**ADDENDUM NO. 1**

**Storefront Window Replacement @ William Guste School**

**Project #ITB24-FAC-0015**

OPENING SCHEDULE AND DETAILS

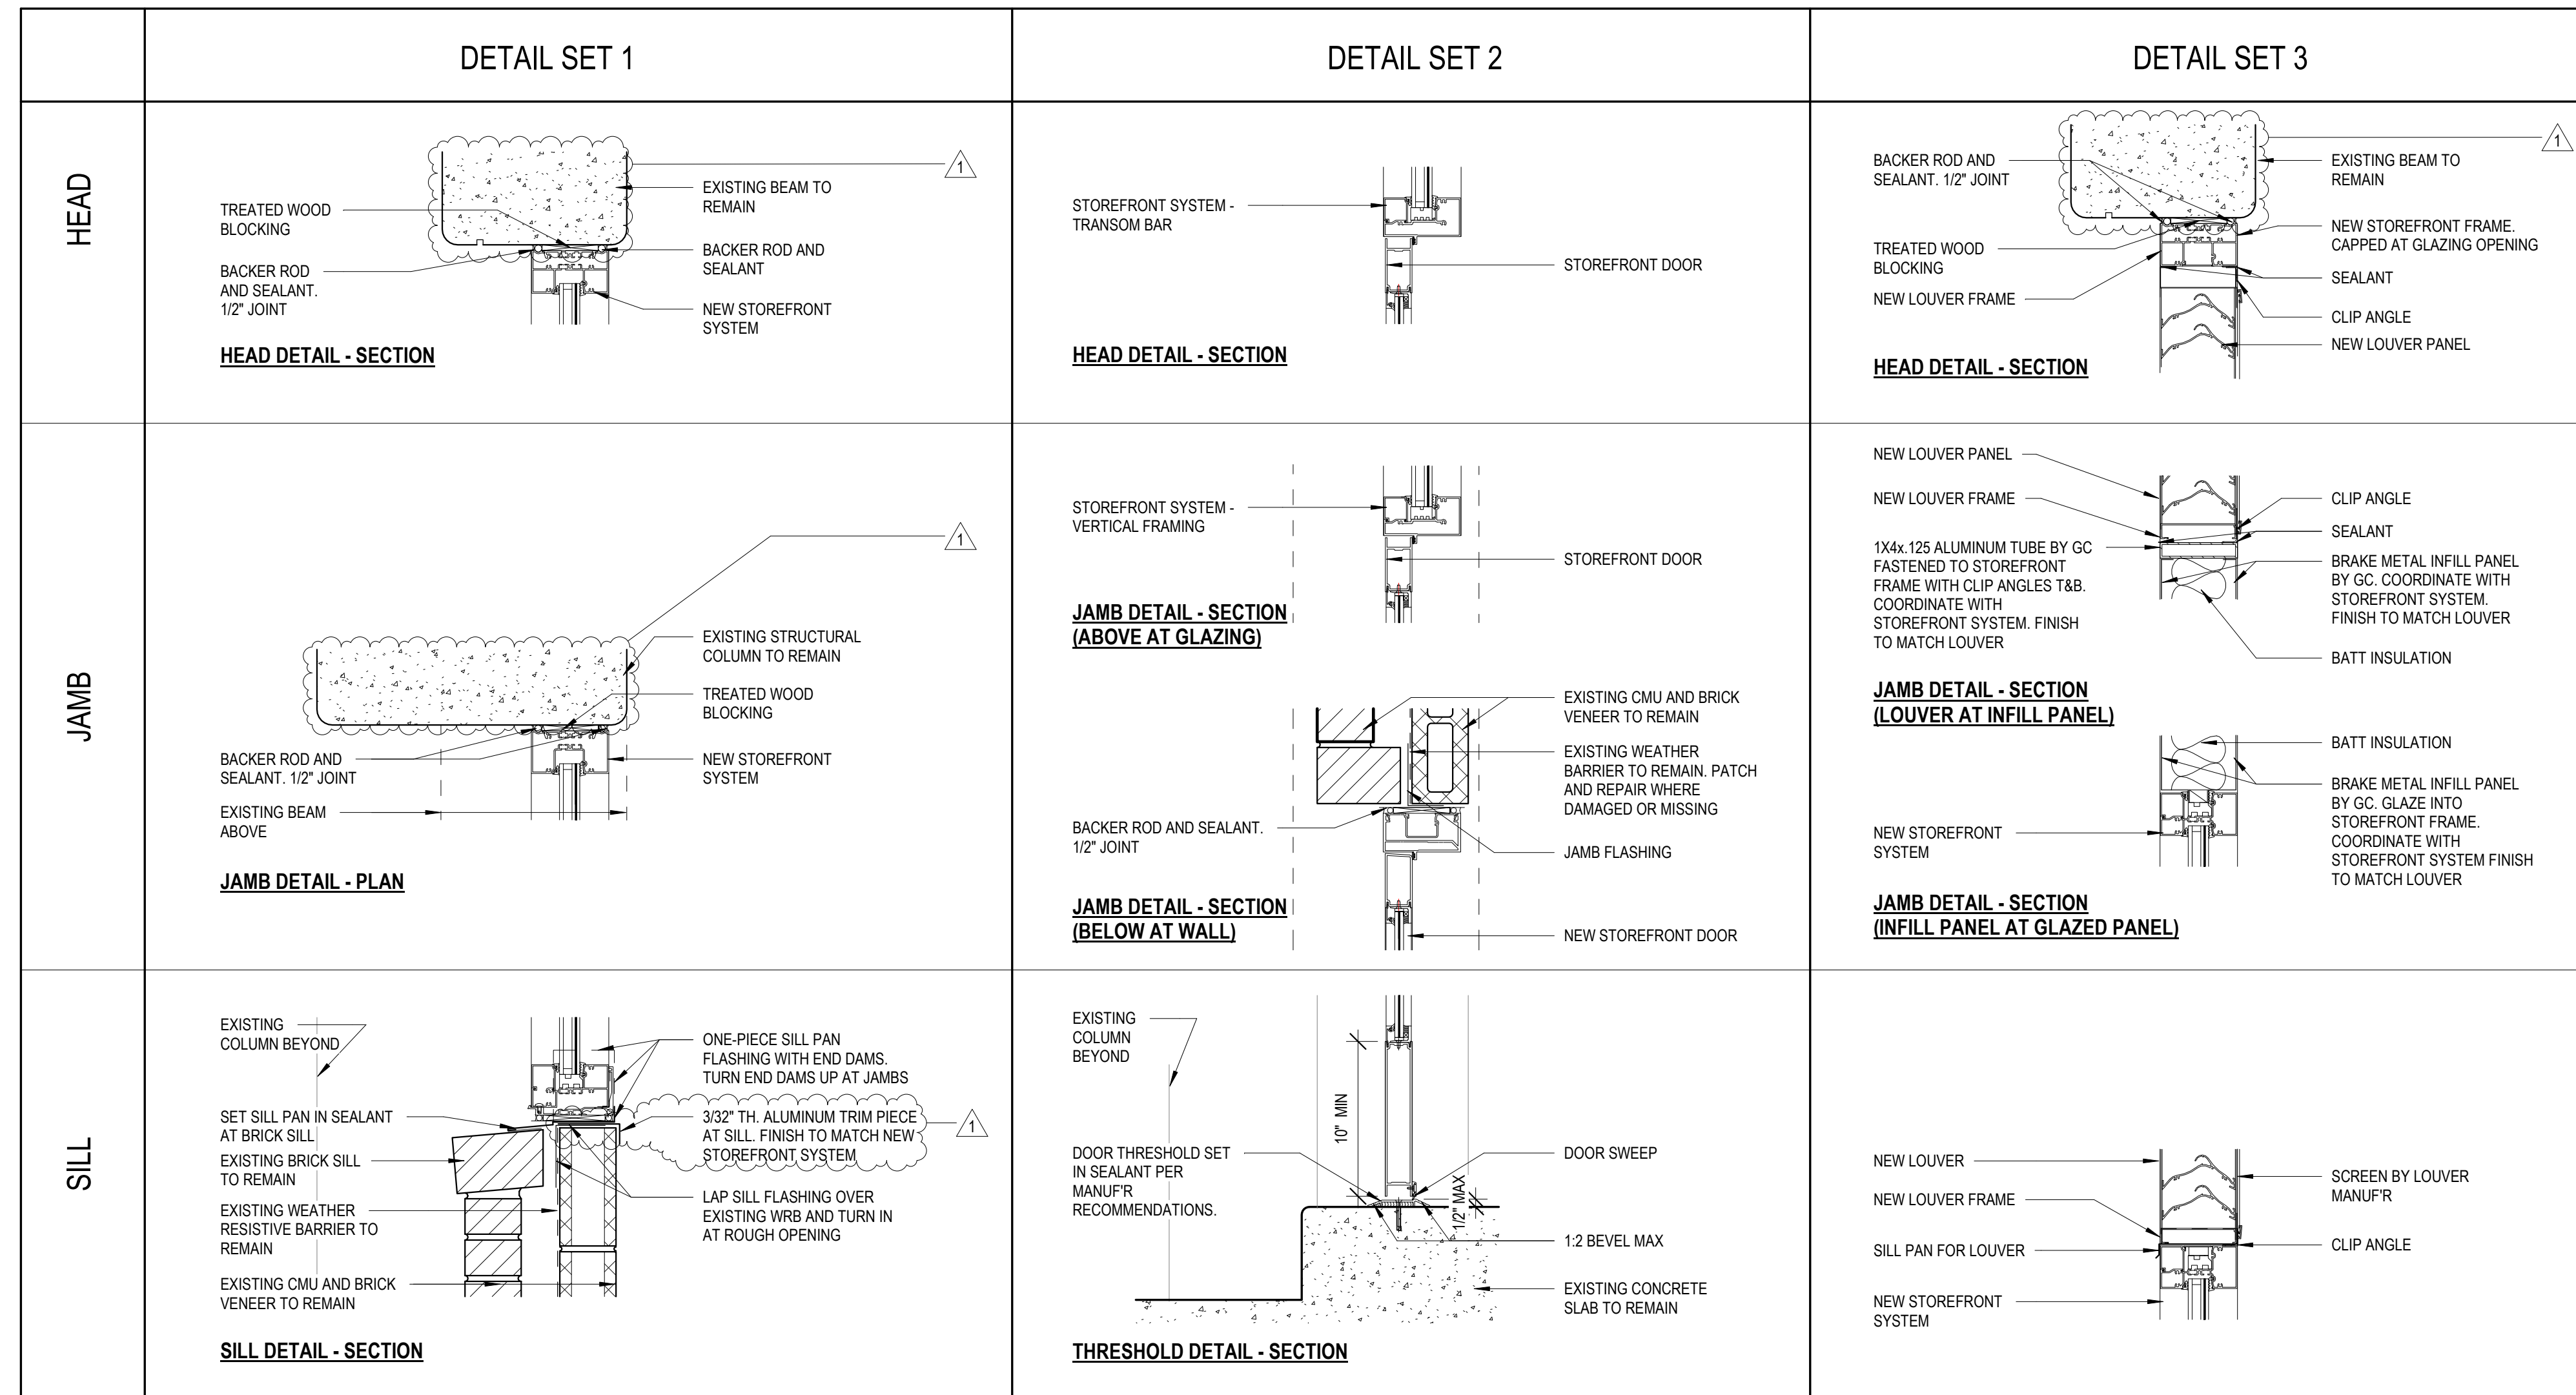
Item	Date	Description
G000 TITLE SHEET	08/26/2024	Revise Sheet Index to indicate revised drawings sheets
A302 OPENING SCHEDULE AND DETAILS	08/26/2024	Revise Storefront sill detail 1/A302. Add Aluminum trim piece to all new sills.
A302 OPENING SCHEDULE AND DETAILS	08/26/2024	Clarify graphic representation of existing structure 1/A302 and 3/A302
Pre-Bid Meeting	08/22/2024	Meeting Minutes

**A:** CMU back up wall at sills and base of doors. Typical jambs and heads are at structure. Clarification that structure is concrete. See revised sheet A302 as part of this Addendum.
